## **GUCOM LODGE SUBDIVISION**

APPLICATION NUMBER 23 DATE October 18, 2007

REQUEST Subdivision

# DETAIL SITE PLAN

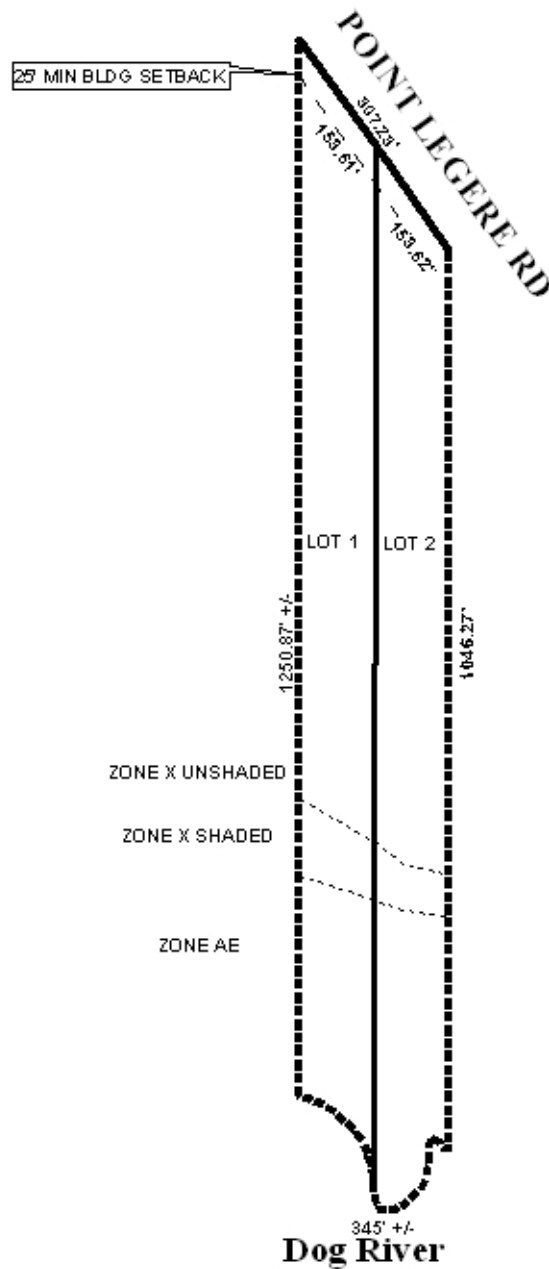
The site fronts Point Legere Road, a minor street, and has 30 feet of right-of-way. Section V.B.14. of the Subdivision Regulations requires minor streets without curb and gutter to have 60 feet of right-of-way; therefore, the plat should be revised to dedicate 30 feet from the centerline of Pointe Legere Road.

Since the site has approximately 153 linear feet of frontage per lot along Point Legere Road, a note should be placed on the final plat stating that the site is limited to one curb cut for each lot, with the size, location and design to be approved by Traffic Engineering and conform to AASHTO standards.

The proposed lots will exceed the depth to width ratio recommended by Section V.D.3. of the Subdivision Regulations. However, it should also be pointed out that lots exceeding the

recommended depth to width ratio are common along Dog River, thus a waiver of Section V.D.3. may be appropriate.

The site is bounded to the South by Dog River, and wetlands and floodplains associated with the waterway may occur on a portion of the site. The presence of wetlands and floodplains indicate that the area may be environmentally sensitive; therefore, the approval of all applicable federal, state and local agencies would be required prior to the issuance of any permits or land disturbance activities.

The plat does not indicate the square footage of the lots, and it does not depict the existing structure, which should be addressed before signing the final plat. It should also show side and rear building setbacks.

With the waiver of Section V.D.3., the plat is recommended for Tentative Approval, subject to the following conditions:

1. labeling of the lot with its size in square feet, or the provision of a table on the final plat with the same information;
2. dedication of 30 feet from the centerline of Point Legere Road, compliant with Section V.B.14. of the Subdivision Regulations;

3. placement of a note on the final plat stating that the site is limited to two curb cuts, with the size, location, and design to be approved by Traffic Engineering, and conform to AASHTO standards; and

4. subject to the Engineering Comments (*Show minimum finished floor elevation on each lot. It is the responsibility of the applicant to look up the site in the City of Mobile (COM) GIS system and verify if NWI wetlands are depicted on the site. If the COM GIS shows wetlands on the site, it is the responsibility of the applicant to confirm or deny the existence of wetlands on site. If wetlands are present, they should be depicted on plans and/or plat, and no work/disturbance can be performed without a permit from the Corps of Engineers. Must comply with all storm water and flood control ordinances. Any work performed in the right of way will require a right of way permit.*)
